A417 Missing Link
TR010056

7.5 Route Options Consultation
Report (March 2019)

A417 Missing Link

7.5 Route Options Consultation Report (March 2019)

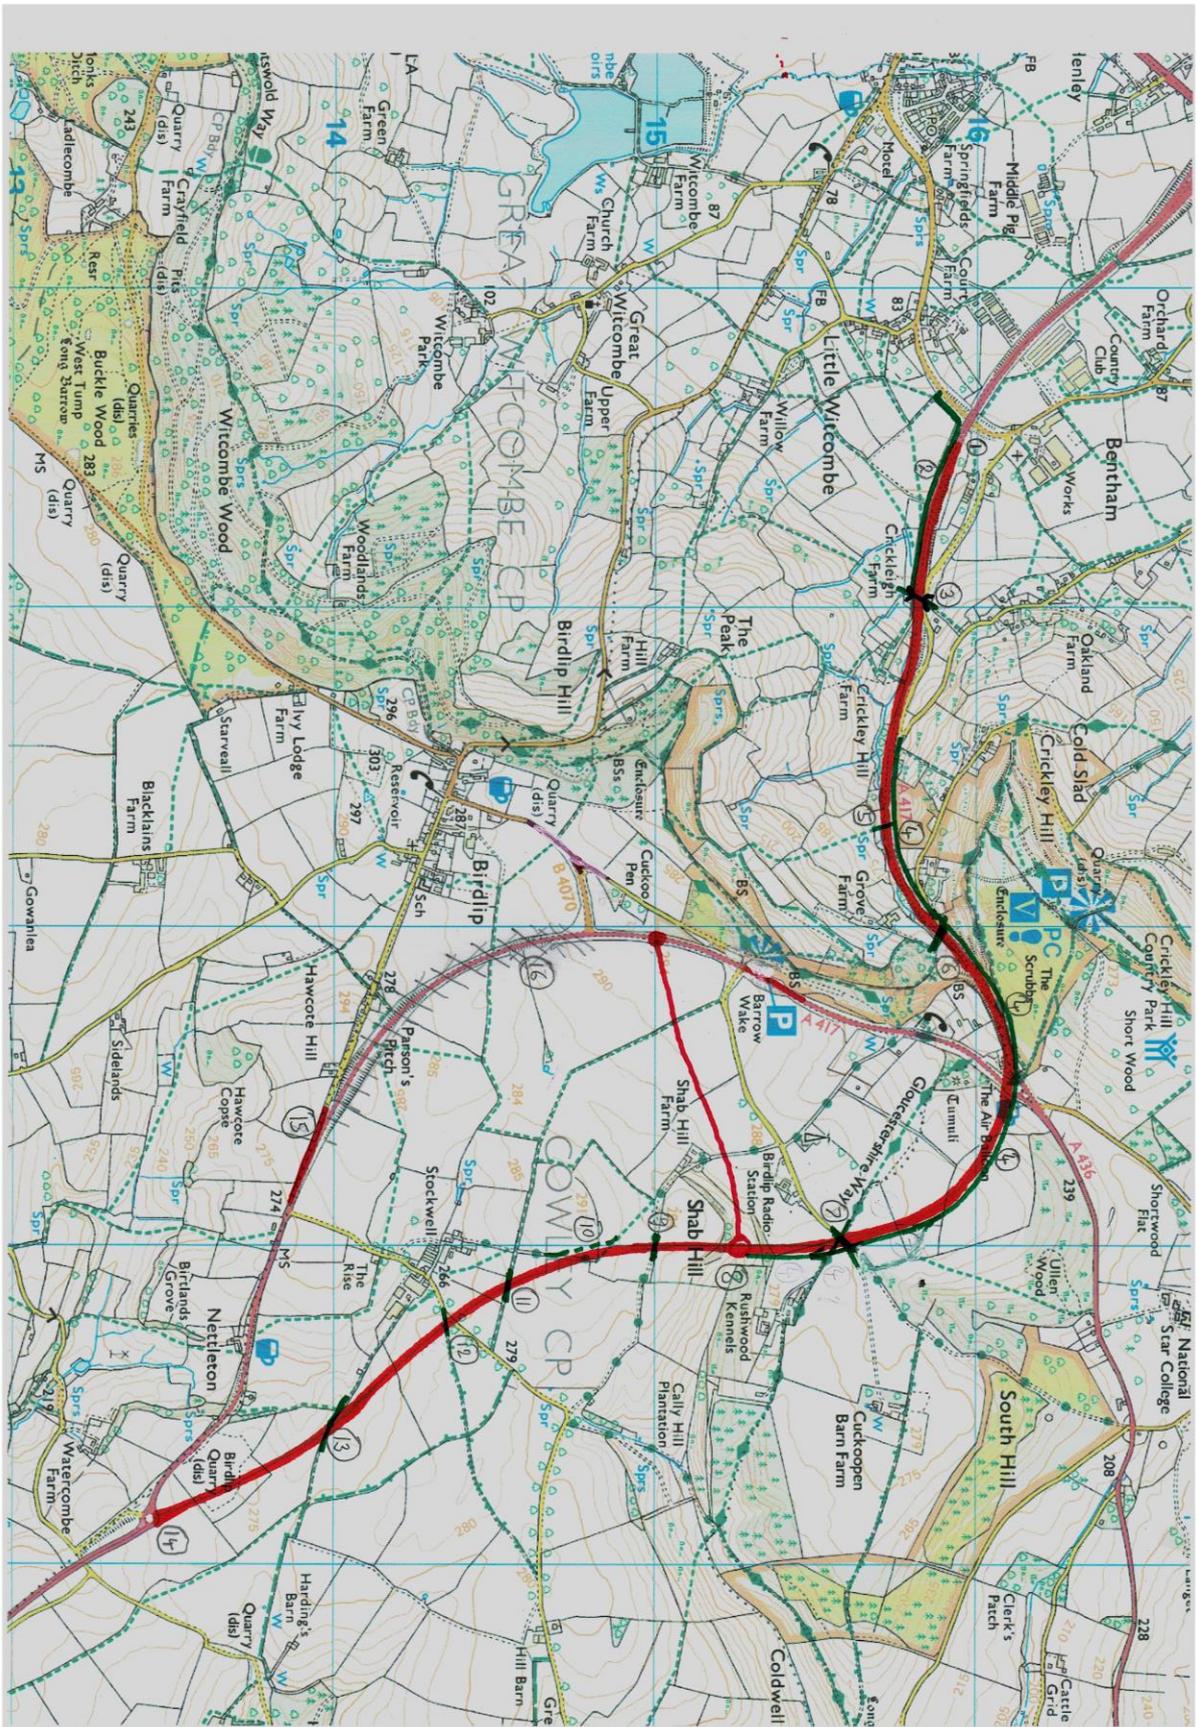
There are also many footpaths and tracks crossing the proposed route, so we have superimposed this on an Ordnance Survey map (enclosed) to illustrate our proposal for a shared use path up the escarpment, and the public footpaths and tracks which cross it.

- 1) Start of road link
- 2) Resurface existing public track (PT)
- 3) Grade separated crossing for track and public footpaths (PFs)
- 4) Start of shared use cycle link (also preserving pedestrian connections with Dog Lane, the road to Cold Slad and the PFs currently using the A417 verge locally.
I've shown it on the uphill side – reducing danger from traffic.
Ideally separated from and uphill from A417, with landscaped buffer strip between.
- 5) Crossing for PF
- 6) Crossing for PFs
- 7) Grade separated crossing for PFs, PTs and road (slightly rerouted to all use same crossing)
- 8) Interchange with new A436 link road; cycle track joins with new A436 road link.
- 9) Grade separated crossing for PT
- 10) Re-routed PF (economy – removes the need for crossings)
- 11) Grade separated crossing for PT
- 12) Grade separated crossing for PF & road (slight realignment of PF to suit)

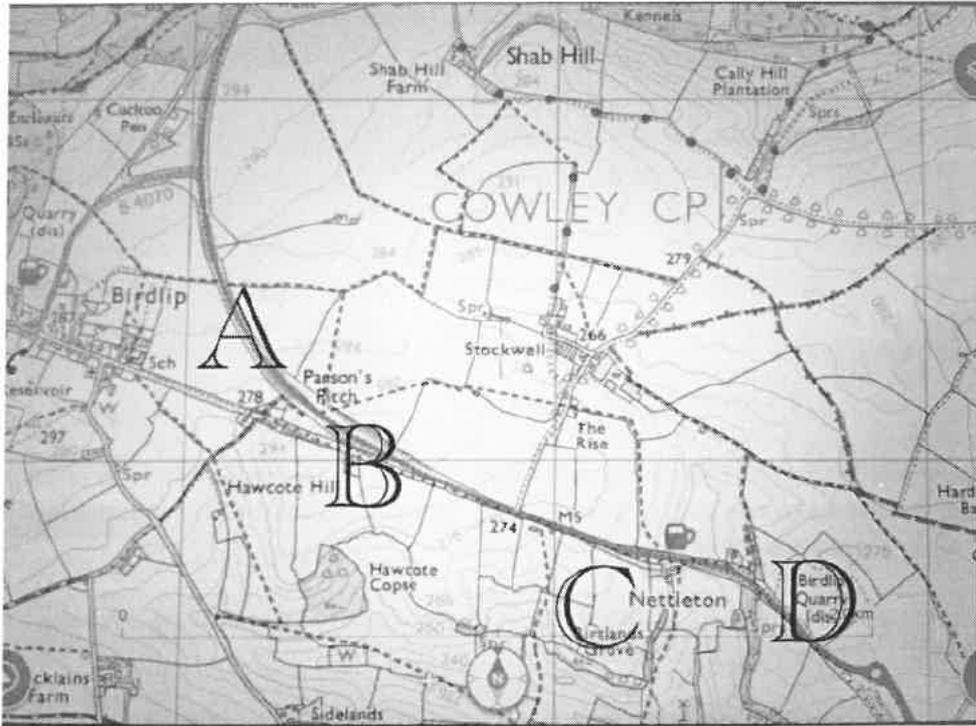
While we want to emphasise these two long distance routes, there are many other paths in the area of interest for the new scheme which are potentially threatened. We urge you to avoid any repetition of the situation between Birdlip and Nettleton where footpaths at A, B, C, & D to all practical purposes stop at the highway edge in the absence of any assistance to protect people crossing – see below. This amounts to reduction in quality of life for users of these paths.

We are concerned that current proposals which appear to rule out the most environmentally sensitive options on the grounds of immediate cost, do not take into account the far greater costs which would be incurred by a very lengthy period of unacceptable traffic hold ups during the construction period which would generate huge hidden costs to business which could well result in the total cost of the project making a surface option less attractive and in fact more equal to the cost of the tunnel options. If evidence of this is needed, then the half empty supermarket shelves in the first week of March after a few days' unseasonal snow, is proof positive of the costs of disrupting normal traffic flows.
